Docket No. 50-263

CHANGE NO. 14 TO APPENDIX A TECHNICAL SPECIFICATIONS

NORTHERN STATES POWER COMPANY

Amendment No. 3
License No. DPR-22

FIGURE 2.1.1 FUEL CLADDING INTEGRITY SAFETY LIMIT

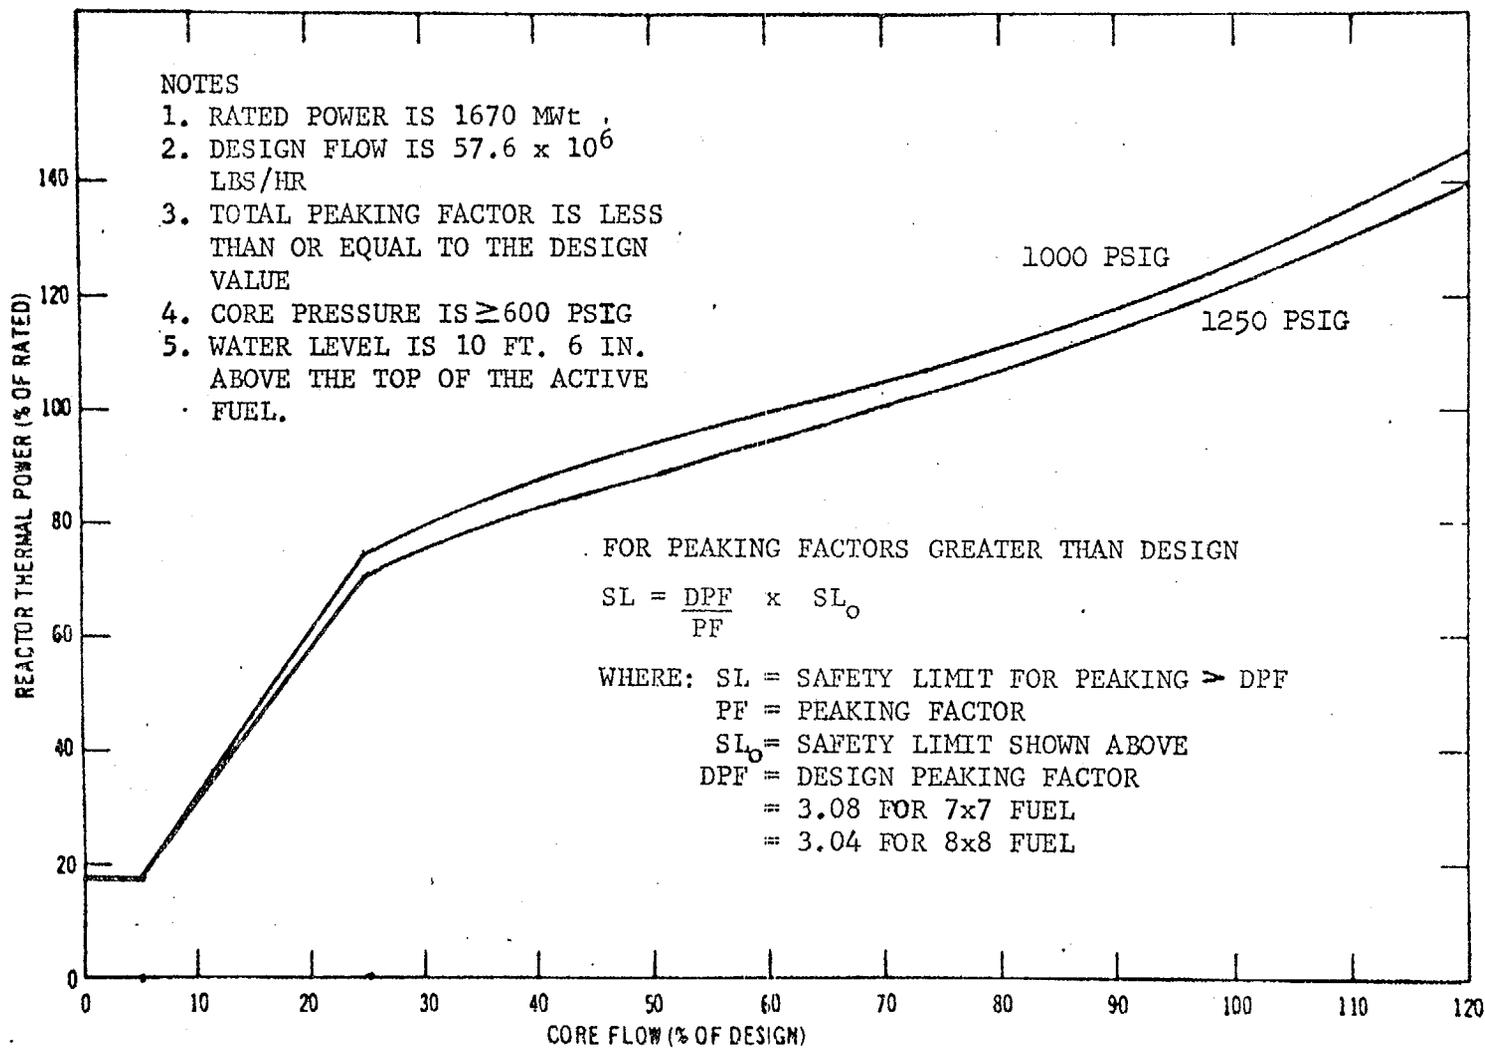
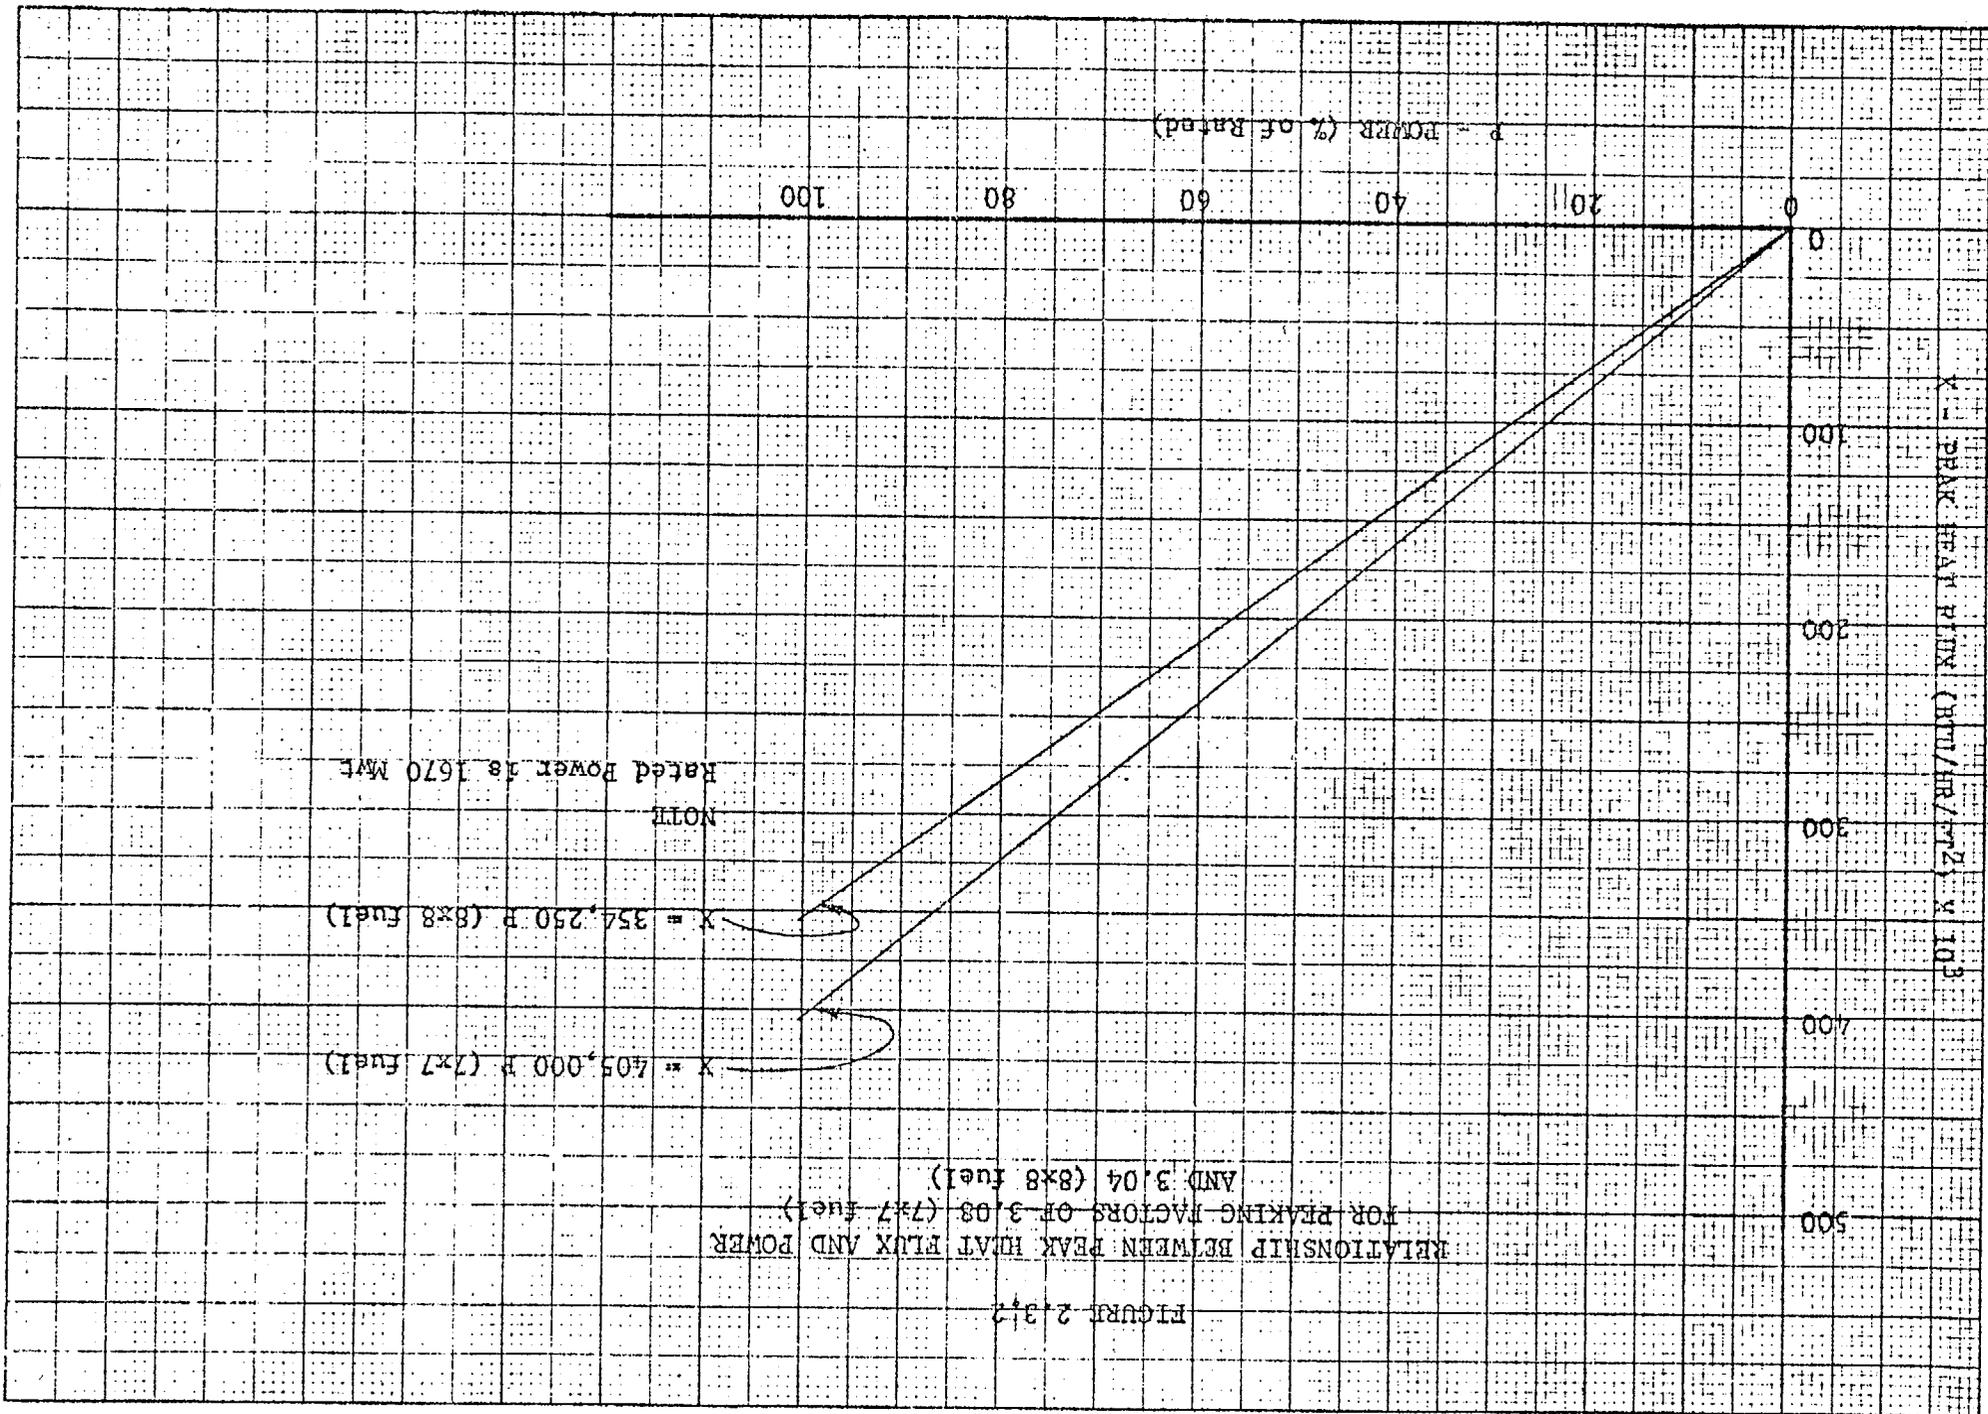
The power shape assumed in the calculation of these curves was based on design limits and results in a total peaking factor of 3.08 for 7x7 fuel and 3.04 for 8x8 fuel. For any peaking of smaller magnitude, the curves are conservative. The actual power distribution in the core is established by specified control rod sequences and is monitored continuously by the in-core Local Power Range Monitor (LPRM) System. To maintain applicability of the safety limit curve, the safety limit will be lowered according to the equation given in Figure 2.1.1 in the rare event of power operation with a total peaking factor in excess of the design value.

The thermal hydraulic safety limit of Specification 2.1 was based on a total peaking factor of 3.08 for 7x7 fuel and 3.04 for 8x8 fuel. A factor has been included on Figure 2.1.1 to adjust the safety limit in the event peaking factor exceeds the design value. Likewise, the scram setting should also be adjusted to assure MCHF_R does not become less than 1.0 in this degraded situation. This has been accomplished by use of Figure 2.3.2. If the combination of power and heat flux is greater than shown by the curve; i.e., a peaking factor greater than the design value exists, the APRM scram setting is adjusted downward by the formula given in the specification. The scram setting as given by the equation will prevent MCHF_R from becoming less than 1.0 for the given heat flux condition for the worst expected transients. If the APRM scram setting should require a change due to an abnormal peaking condition, it will be done by increasing the APRM gain and thus reducing the slope and intercept point of the flow - biased scram curve by the reciprocal of the APRM gain change.

Maximum
Average
Planar
LHGR
(kw/ft)

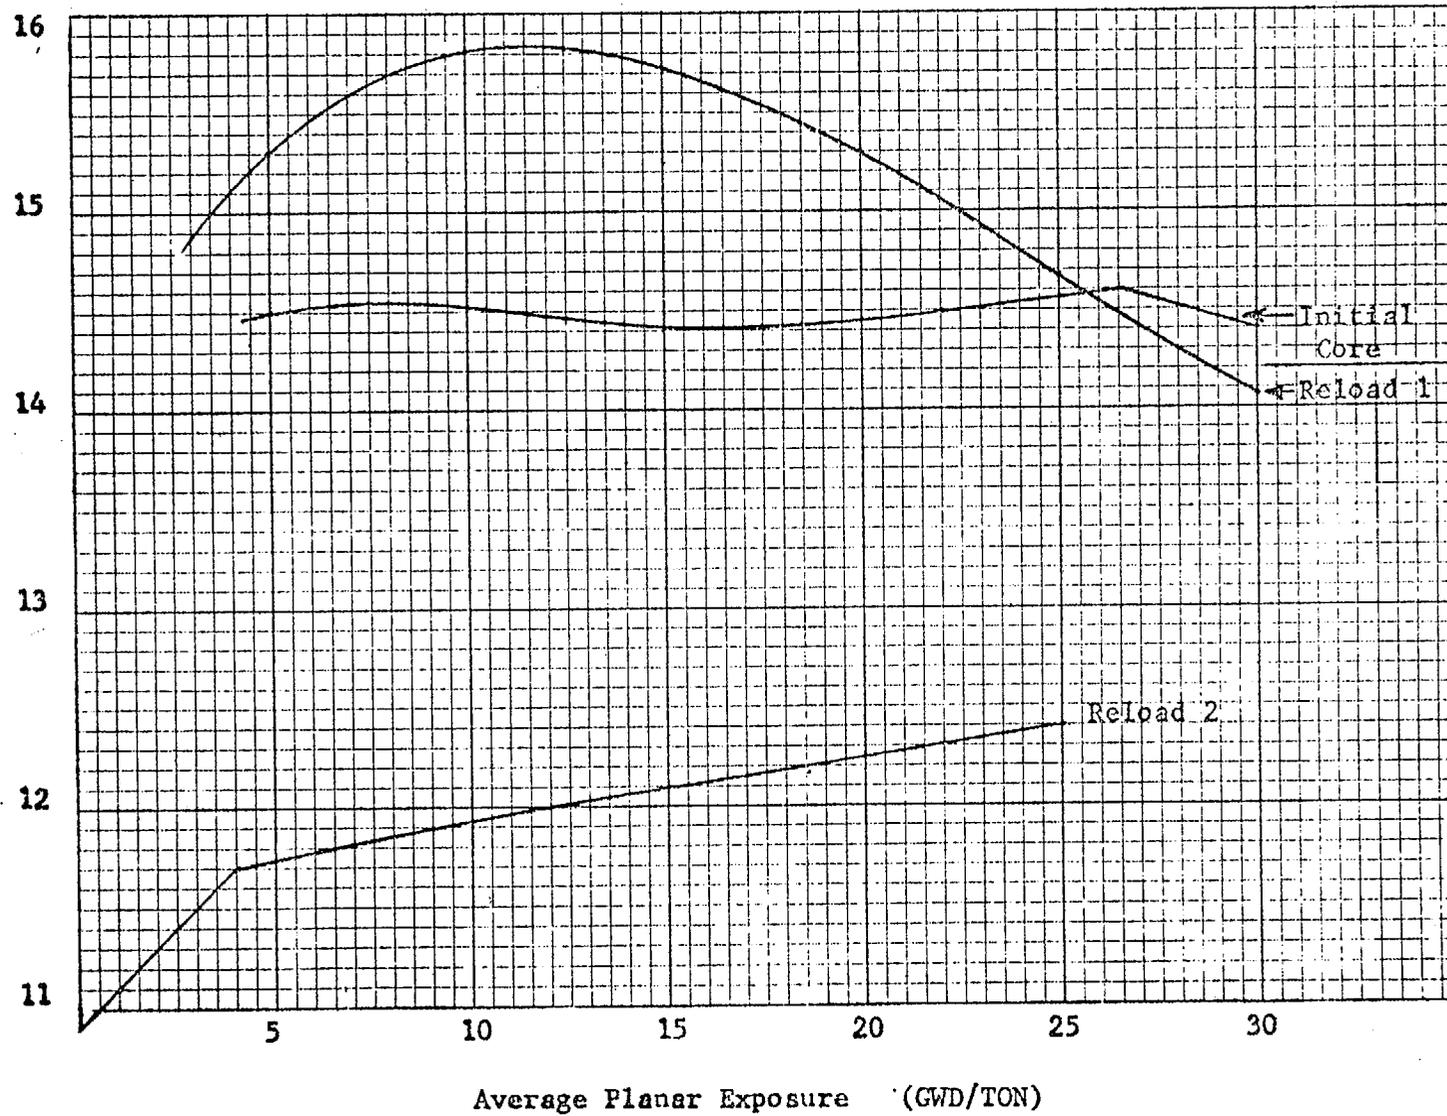
During steady state power operation, the average linear heat generation rate (LHGR) of all the rods in any fuel assembly, as a function of average planar exposure, at any axial location, shall not exceed the maximum average planar LHGR shown in Figure 3.5.1.

The maximum average planar LHGR curves shown in Figure 3.5.1 were calculated for the various Monticello fuel types in the manner discussed in Section 4.3 of General Electric topical report, "GEGAP-III: A Model for the Prediction of Pellet-Cladding Thermal Conductance in BWR Fuel Rods", NEDO-20181, Revision 1, November 1973. These curves show the composite limitation based on the design LHGR of the fuel and the peak cladding temperature in the event of a LOCA. Calculations based on the AEC "Modified GE Model for Fuel Densification" attached to a December 5, 1973 letter from D J Skovholt (USAEC) to L O Mayer (NSP).
